SAFETY EVALUATION REPORT
Related to the Renewal of the Operating License for the TRIGA Research Reactor at the Kansas State University

Docket No. 50-188

U.S. Nuclear Regulatory Commission
Office of Nuclear Reactor Regulation

March 13, 2008

Figure 13.1 Core and biological shielding, MCNP model

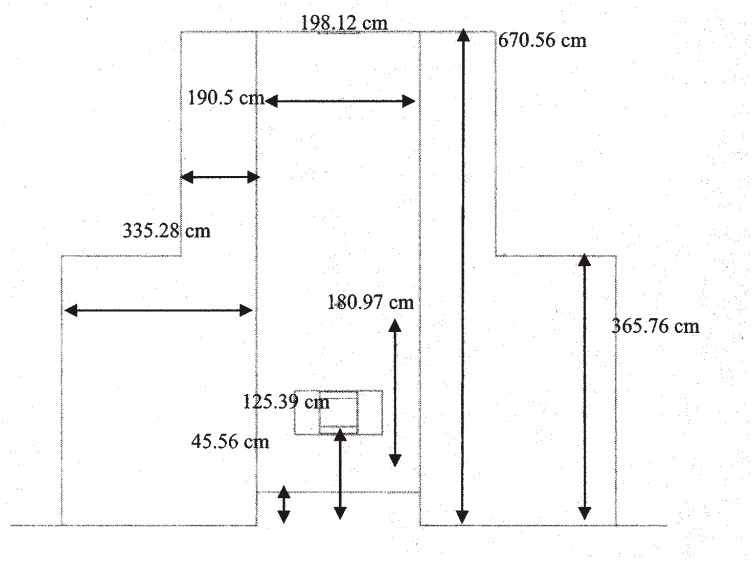
The model approximates the reactor core as a right circular cylinder with a diameter of 45.6 cm and a height of 38.1 cm. On the top and bottom of the core are a graphite zone and aluminum grid plates. The core contains fuel elements, three standard control rods and one transient control rod, one void location, one central thimble (void), one source (void), and one pneumatic transfer site (void). The biological shielding is approximated as two concrete cylinders. The lower cylinder is 335.38 cm thick at the bottom. At the 12-ft level, the thickness is 190.5 cm.

Figure 13.2 Reactor bay, MCNP model

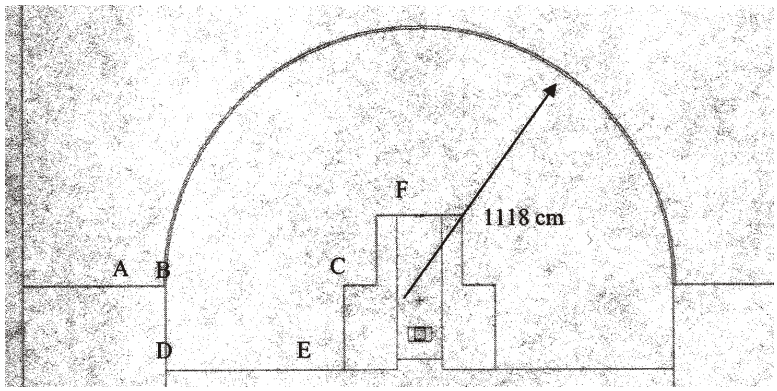
The radius of the hemisphere is 1118 cm as measured from the reactor core. The right circular cylinder also has a radius of 1118 cm and is 365.8 cm high. The dome is a concrete slab 10 cm thick. The reactor bay free-air volume is 144,000 ft^3 (4,078 m^3).

Radiation doses are calculated at various receptor locations within the reactor bay (on site), as shown in Figure 13.2, and at locations outside the reactor bay (off site), as measured from a fence defining the controlled area. The receptor locations are labeled A through F as described below. (The fence is about 2 m from the bay boundary.)
